## Formal Objection to SSD Trinit Lighthouse Build-to-Rent, North Ryde (SSD-55844212)

I am writing to formally object to the proposed SSD Trinit Lighthouse Build-to-Rent development in North Ryde (SSD-55844212).

View from Ryde Gardens

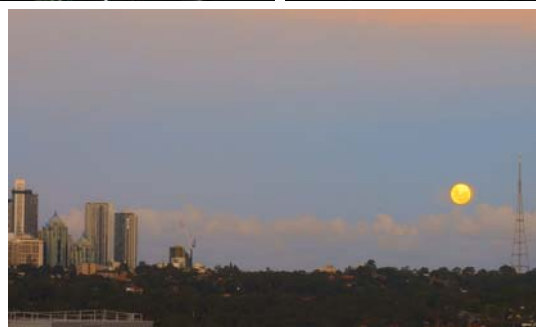
The views presented in the Visual Impact Assessment report are somewhat misleading. The photo on the left below shows the actual view from Ryde Gardens, while the image on the right is taken from the report. The camera angle used in the report appears highly distorted and does not accurately represent the true outlook experienced by residents. This raises serious concerns about the accuracy and reliability of the overall visual impact assessment.

1 2 BED LHA TYPE 3  
1:50  
LOCATION: BUILDING C LEVEL 11-19  
UNIT: C11-19.01  
TOTAL: 9

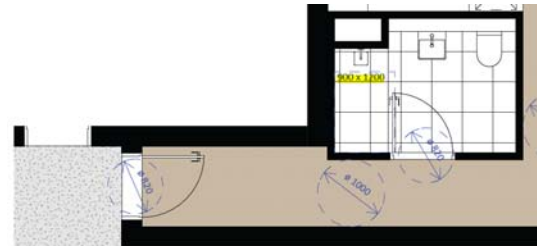
Additional fundamental errors can be found on **Page 23** A-DA-0754\_B.

The 900X1200 clearance should be in front of toilet pan, NOT in the shower.

3 2 BED LHA TYPE 4  
1:50  
LOCATION: BUILDING C LEVEL 11-19  
UNIT: C3-19.03  
TOTAL: 9

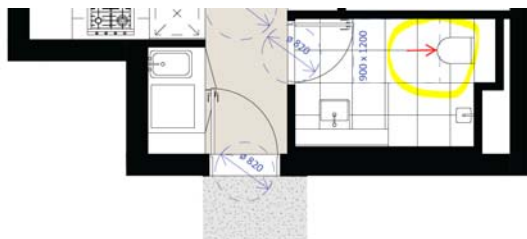
Clearance space clashed with toilet pan.
